EQUIPMENT/FURNISHINGS - OPTION FOR LARGER HEADSET HOOK

To provide an option to install a larger headset hook.

SB525B-25-09
Page 1 of 6

Figure 1. Headset Hook Installation (Sheet 1)

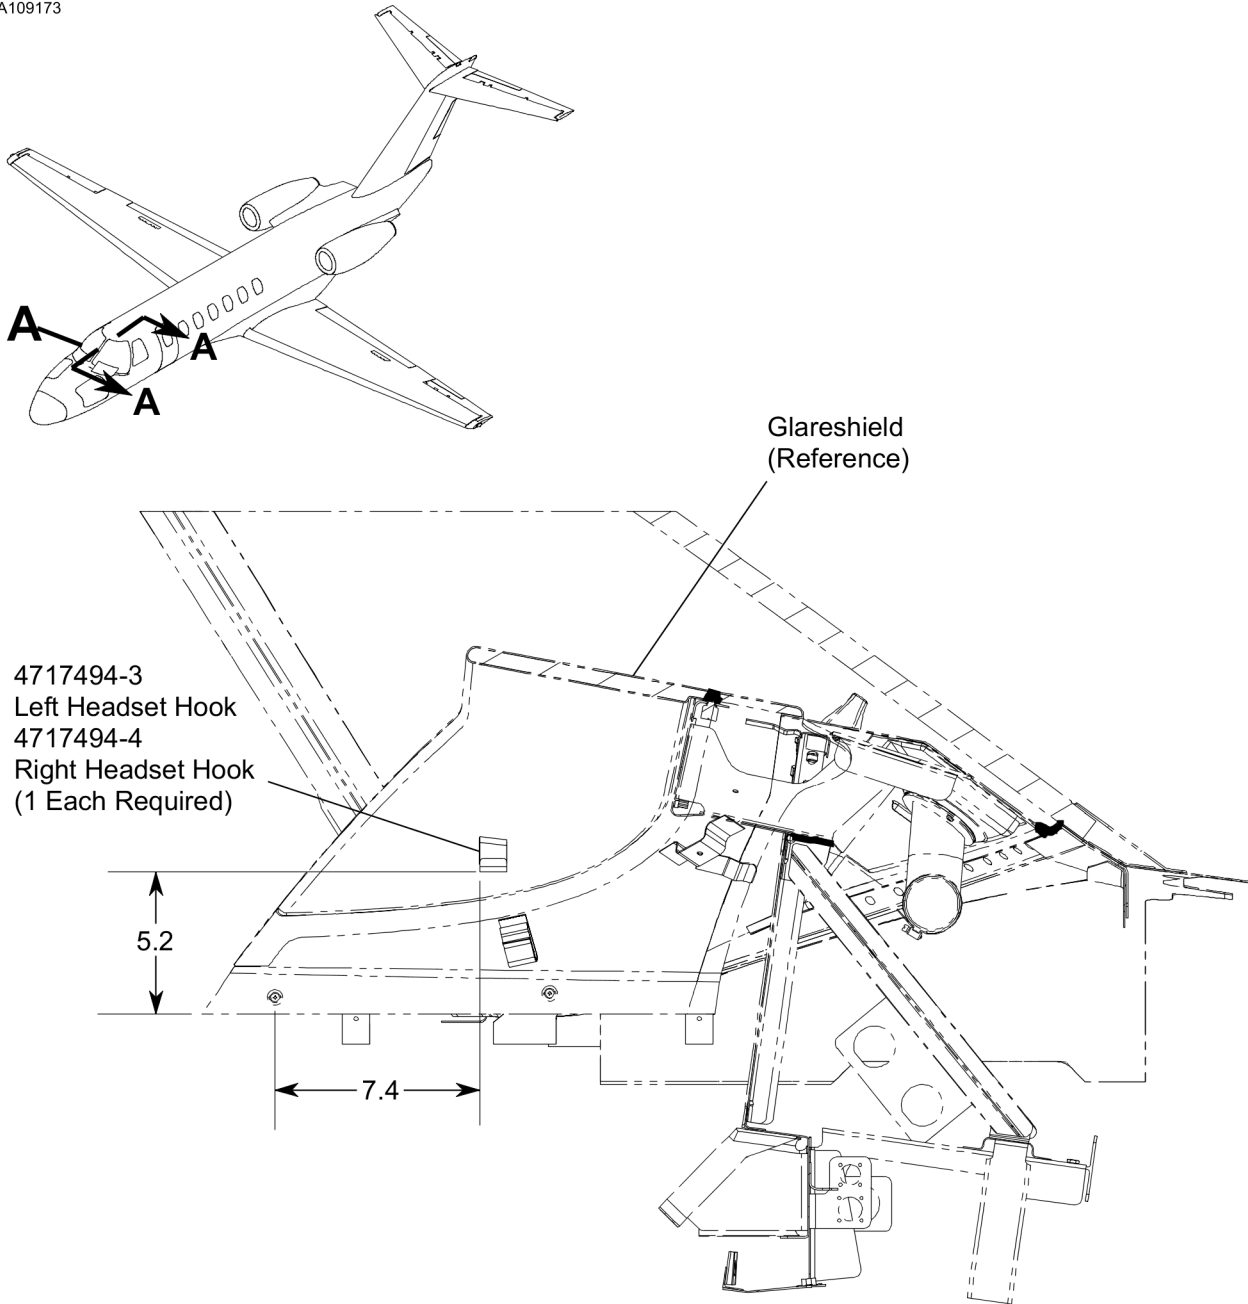
This service bulletin provides parts and instructions to install a larger headset hook.

2. (Refer to Figure 1, Detail A and View A-A.) Install the 4717494-3 Left Headset Hook.
 - A. Lightly abrade the mating surface of the glareshield and the headset hook.

3. (Refer to Figure 1, Detail A and View A-A.) Do Step 2.A. thru 2.F. to install the 4717494-4 Right Headset Hook.
4. Remove the maintenance warning tags and connect the airplane battery.

- D. Apply U158530 Adhesive to the mating surface of the 4717494-3 Left Headset Hook. (Refer to the Citation Standard Practices Manual, Chapter 20, Adhesive and Solvent Bonding - Maintenance Practices.)

- E. Install the 4717494-3 Left Headset Hook on the glareshield.
 - (1) Make sure the hook portion of the headset hook is level.
 - F. Wipe away excess adhesive with isopropyl alcohol.
